BOARD OF WATER SUPPLY

Subject: Honolulu Board of Water Supply (BWS) Comments on the Red Hill
Administrative Order on Consent (AOC) Statement of Work (SOW)
Sections 6 and 7 Groundwater Modeling Working Group Meeting
(GMMWG) No. 10 held April 13, 2018

The BWS offers the following comments on the above referenced meeting. Enclosed for reference, as Attachment A, is a copy of the Navy slide presentation from the April 13, 2018 meeting.

Figure 1. Observed Groundwater Levels from 2017-2018 Synoptic Water Level Survey

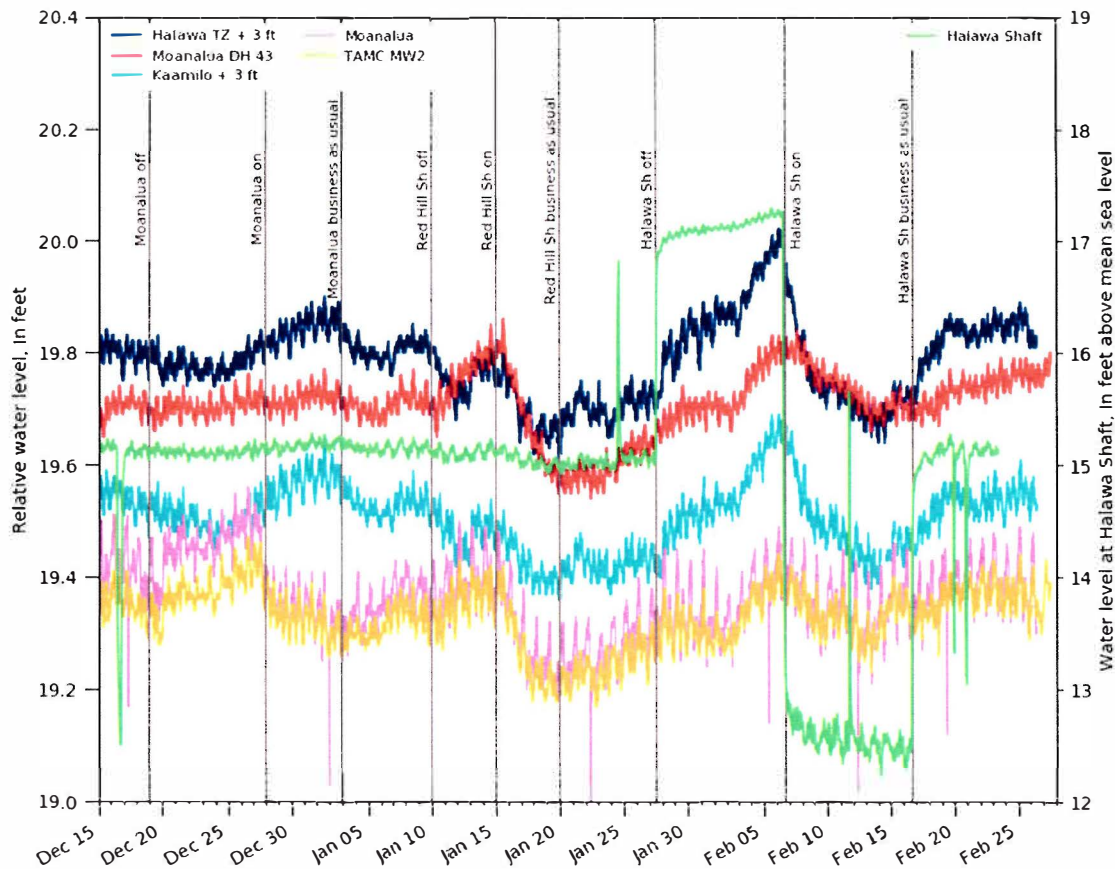
group meeting further demonstrated the interim groundwater model's inability to provide a reasonable match to observed groundwater levels in the areas of interest. The maps of observed groundwater levels presented by the DOH during the meeting appear to show that groundwater flows from the RHBFSF to the northwest across Halawa Valley, whereas the Navy's interim groundwater model predicted groundwater flow direction is to the southwest, a difference of roughly 90 degrees. USGS plots of groundwater levels observed at Moanalua and Halawa Valley wells during the December 2017 through February 2018 time period appear to support the DOH maps. The BWS downloaded the groundwater level data from the USGS website and created the plots in Figures 1 and 2 below. Examination of the Figures reveals that groundwater levels in Moanalua Valley (represented by the Moanalua, DH43, and TAMC MW02 wells) are higher than levels at Red Hill Ridge (represented by OWDFMW01), which are in turn higher than groundwater levels in Halawa Valley (represented by Halawa Shaft, Halawa TZ, and Ka'amilo wells). This observed general pattern is contradicted by the Navy's interim groundwater model's predicted base case groundwater levels for model layer 2 on Slide 29.

Figure 2. Observed Groundwater Levels from 2017-2018 Synoptic Water Level Survey

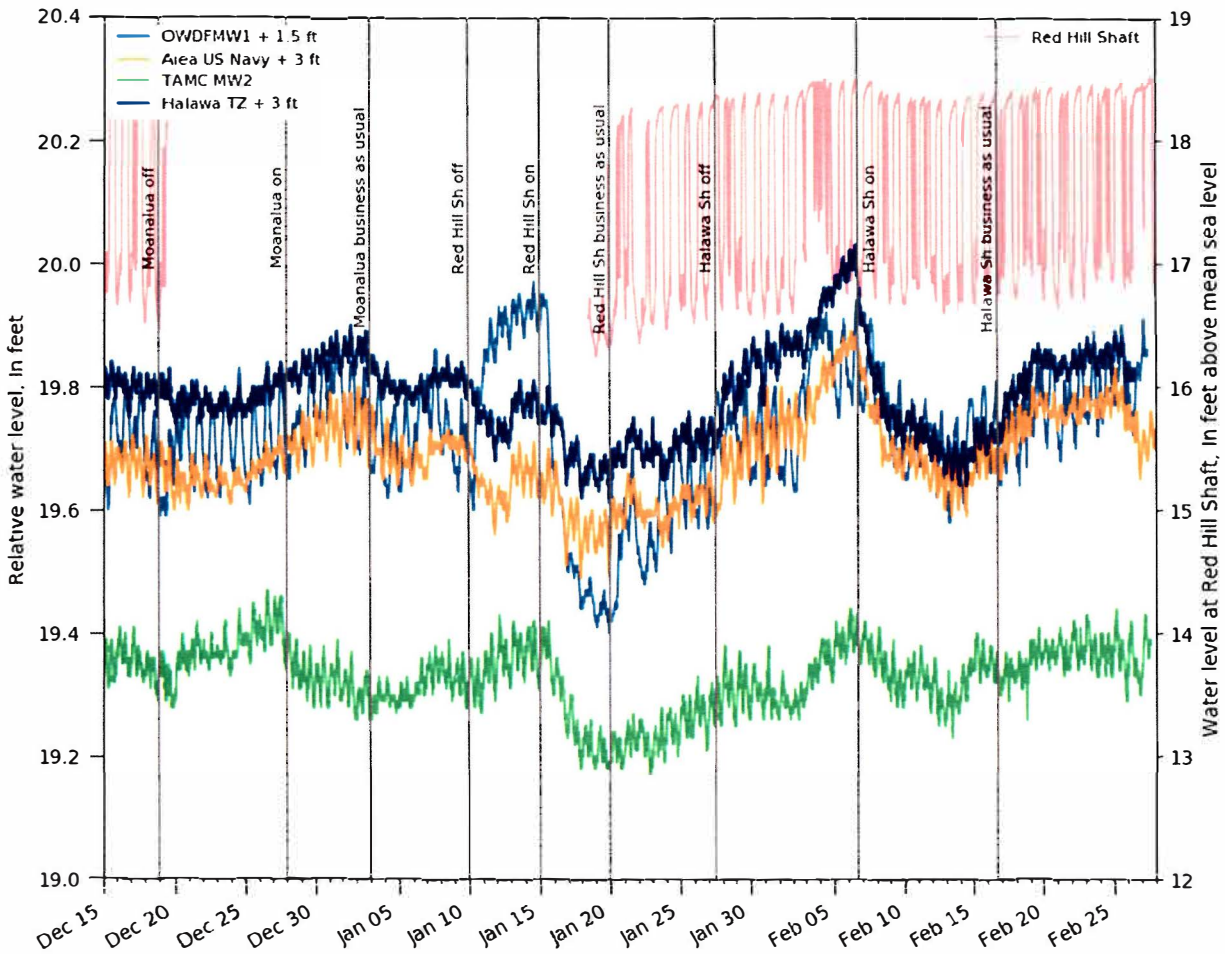
The increasing evidence of the Navy's interim groundwater model's inability to better simulate observed groundwater levels leads the BWS to conclude that we have no confidence in the Navy's interim groundwater flow model. There is abundance of data showing groundwater more likely flows to the north or northwest from the RHBFSF (across Halawa Valley), some of which is described above. Yet, despite the available evidence to the contrary, the interim groundwater model predicts that groundwater flows from northeast to southwest along Red Hill Ridge. The wide gulf between site-specific data and the interim model's predictions is difficult to understand, especially for non-specialists, and could be interpreted as intentional. The BWS cautions the Regulatory Agencies on accepting that the Navy's interim groundwater model can defensibly inform the TUA selection process when so much evidence contradicts both the interim groundwater model's predicted 2017 groundwater levels and its predicted large capture zone across the RHBFSF from pumping at Red Hill Shaft.
